UPGRADING ENTRANCE TO VERONICA VALLEY PARK

(OFF M641) SCALE: 1" = 20'

VV parking lot

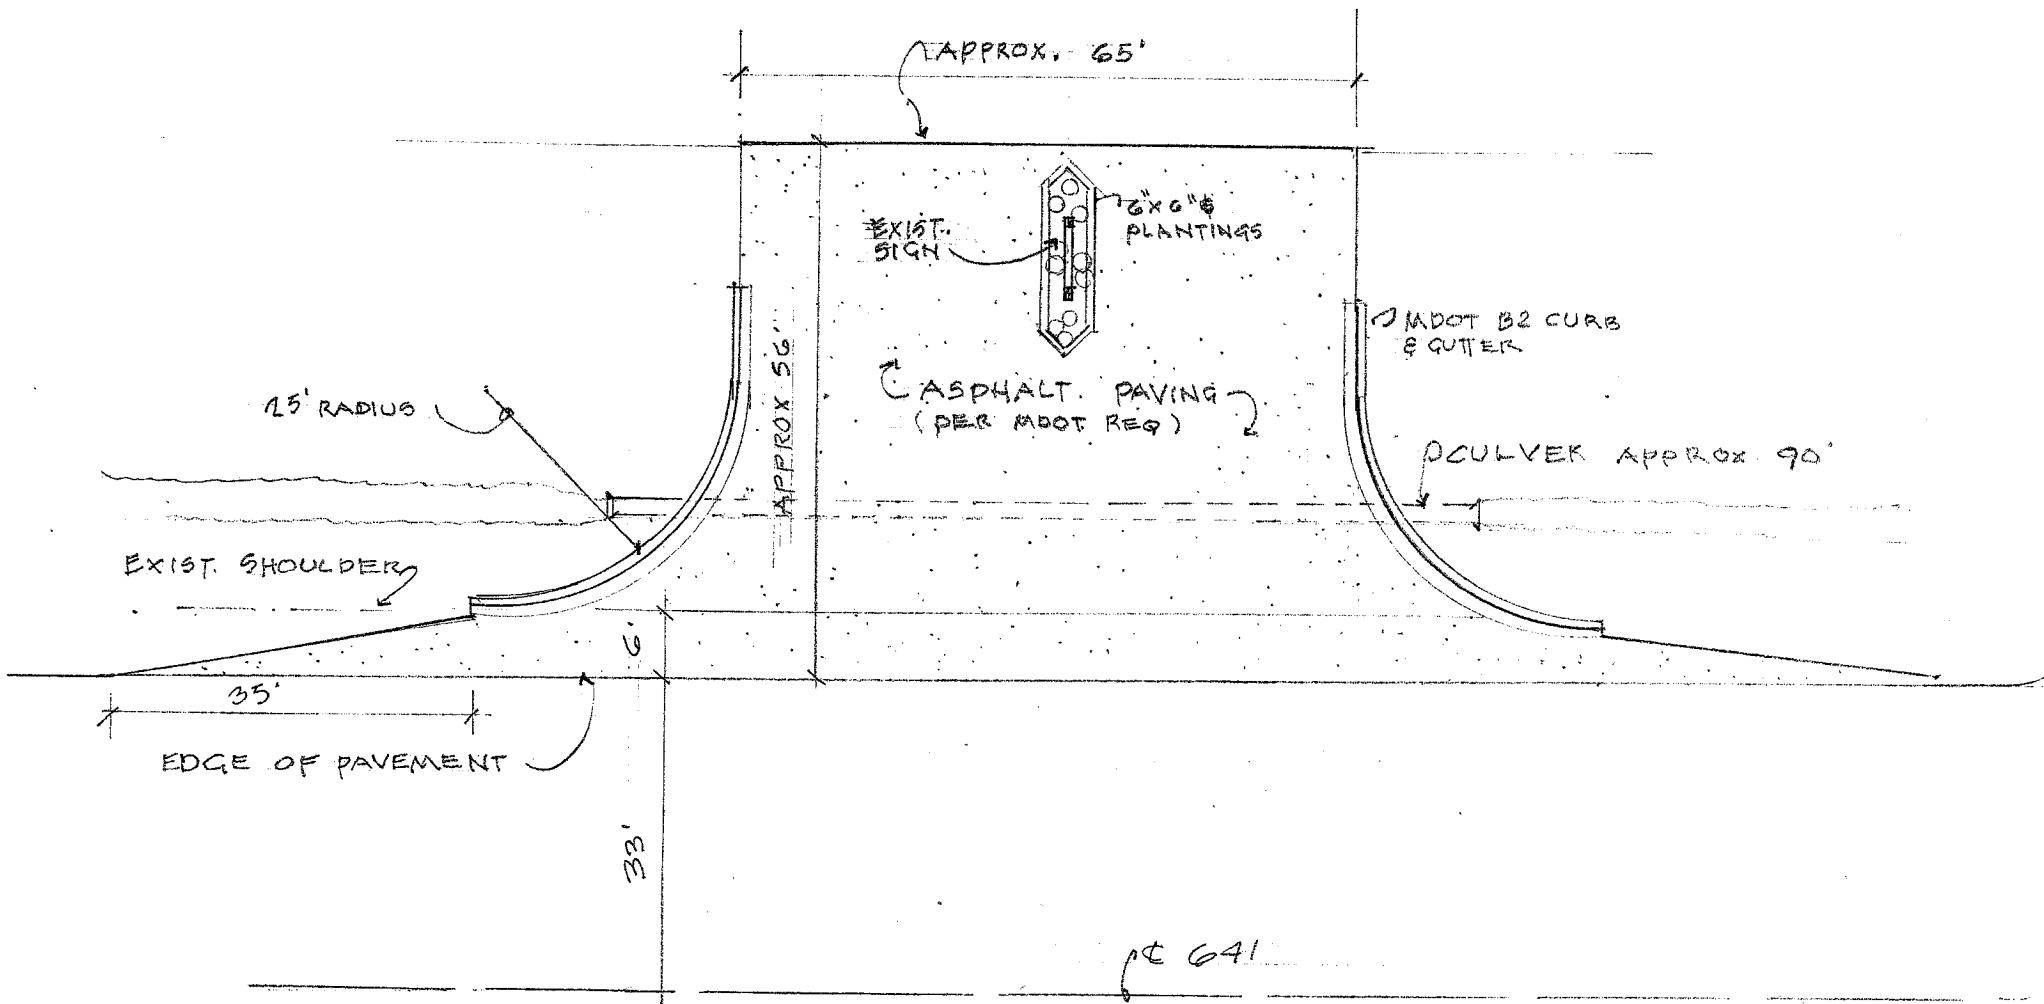
Like I said in the meeting yesterday, 10 cars would be a big crowd on an average day, not to say only ten families visit the park but most don't stay long. The current lot is capable of close to 100 cars if it were lined. I think your vision of 26 spots would be perfect with the bus turn around. I plow the snow off to the swamp side until we get a deep snow then I push it to all four sides of the lot. Plowing near the porta pottys is a challenge as is the entrances to the park though the split rail fence. Curved areas are the hardest to plow because the snow won't carry on the plow when turning.
